Date: June 15, 2004
Refer to: ER2004-0310

**SUBJECT: CROSSWALK OF DRAFT CONSENT ORDER AND LANL INVESTIGATION
WORK PLAN REQUIREMENTS FOR INTERMEDIATE AND REGIONAL
AQUIFER WELLS IN LOS ALAMOS CANYON AND PUEBLO CANYON**

The purpose of this letter is to amend the scope of work proposed in the Los Alamos Canyon and Pueblo Canyon Intermediate and Regional Aquifer Groundwater Work Plan submitted to the New Mexico Environment Department (NMED) on December 30, 2003. After submittal of the above work plan, subsequent discussions with the NMED clarified the expectation that a crosswalk between the draft Consent Order requirements and the work plan be provided by LANL. The attached table provides the crosswalk of the Order and the LANL work plan requirements for installation of intermediate and regional aquifer wells in Los Alamos and Pueblo Canyons.

Figure 1. Proposed and Installed Intermediate and Regional Aquifer Well Locations in Los Alamos Canyon and Pueblo Canyon

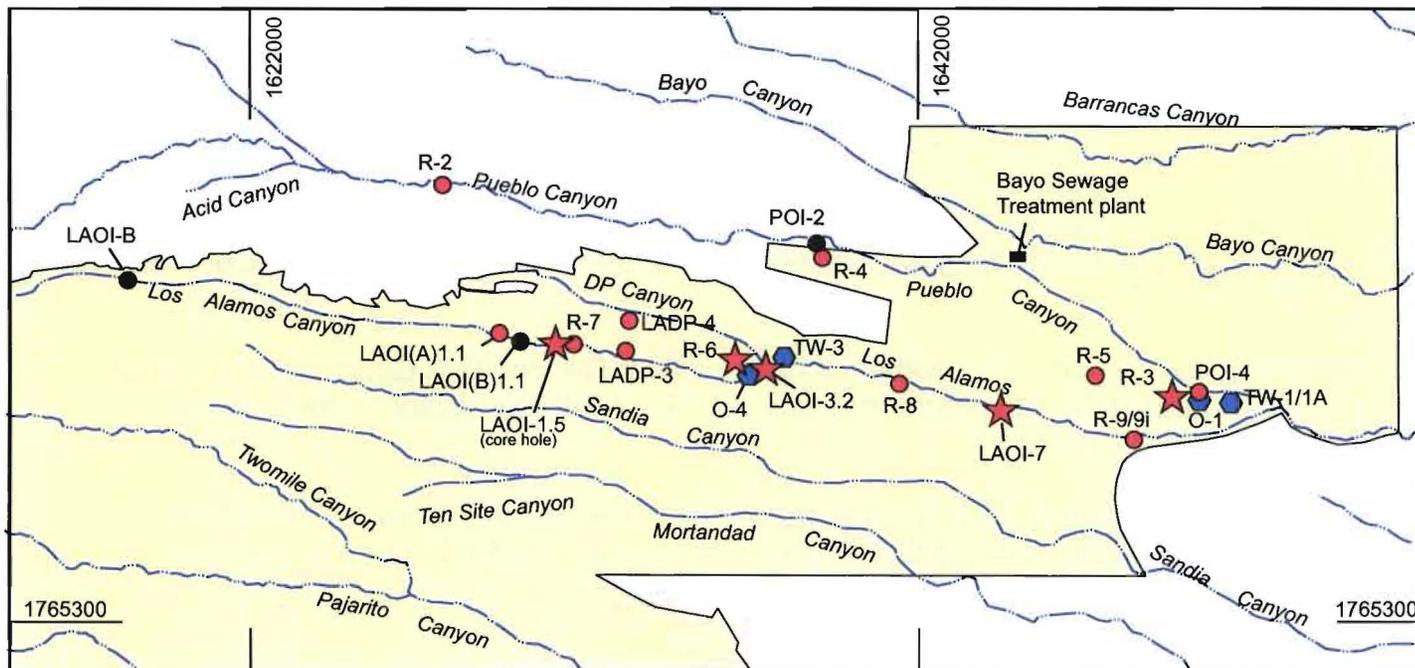
The proposed changes to the December work plan include relocating and constructing regional well R-6 (NMED letter dated May 20, 2004), constructing intermediate well LAOI-3.2, and collecting core at the proposed LAOI-1.5 work plan location. The updated scope also includes plugging and abandoning test wells TW-1, TW-1A, TW-2, TW-2A, TW-3, and TW-4.

The characterization objectives and location for LAOI-7 were updated in the Los Alamos and Pueblo Canyons intermediate and regional aquifer groundwater work plan (LANL 2003, 82612). Well LAOI-7 was moved upstream from its original location to determine the nature and extent of contamination in intermediate-perched groundwater zones within the Cerros del Rio basalt between wells R-8 and R-9i. Well LAOI-7 had an original total depth (TD) of 150 ft (LANL 1995, 50290) but was revised to 300–400 ft within the Cerros del Rio basalt (LANL 2003, 82612). Well LAOI-7 is planned for construction and will be located between alluvial wells LAO-4.5 and LAO-6 (Figure 1).

Installation of intermediate well LAOI-3.2 was proposed in the Los Alamos and Pueblo Canyons work plan (LANL 1995, 50290, pp. 7-54–7-57) and is located near test well (TW)-3 (see Figure 1). This well was designed to identify whether an intermediate perched zone exists in Los Alamos Canyon between DP Canyon and State Road 4 and if the zone is contaminated. In 1990, a video of O-4 near DP Canyon recorded groundwater cascading into the borehole at a depth of 253 ft bgs within the Puye fanlomerate. Well LAOI-3.2 was to be installed downcanyon of O-4 to confirm the presence of this intermediate perched zone.

Well R-6 will be moved to a new location at the east end of TA-21 near the water supply well O-4. The R-6 investigation will include a mesa-top regional aquifer well and core will be collected in the canyon-bottom as part of the installation of well LAIO-3.2. The regional aquifer well will meet multiple objectives, including investigating radionuclide and hazardous waste constituents, particularly those associated with releases from TA-21, TA-53, and TA-2. Another primary objective of well R-6 is to replace TW-3 which is an old well that lacks a sufficient annulus seal. R-6 will be completed with a screen placed near the top of the regional zone of saturation. The core hole will provide information about infiltration rates in lower DP Canyon by characterizing contaminant profiles through the vadose zone. The core hole will also investigate the possible presence of perched groundwater in the upper part of the Puye Formation near O-4. The data needs and characterization activities for well R-6 were provided to New Mexico Environment Department in the May 20, 2004, letter (LANL 2004, 86553).

Installation of regional aquifer well R-3 was proposed in the hydrogeologic work plan to investigate the continuity, water quality, and hydraulic characteristics of the intermediate perched zone known to exist at TW-2A (LANL 1998, 59599, p. 4-46). Well R-3 is proposed to be moved from upper Pueblo Canyon to the vicinity east of supply well O-1 (Figure 1), as described in the Los Alamos and Pueblo Canyons intermediate and regional aquifer groundwater work plan (LANL 2003, 82612). This well is designed to provide additional contaminant information on the distributions of tritium, nitrate, perchlorate, and uranium observed near the vicinity of O-1 and TW-1. Well R-3 will replace TW-1.
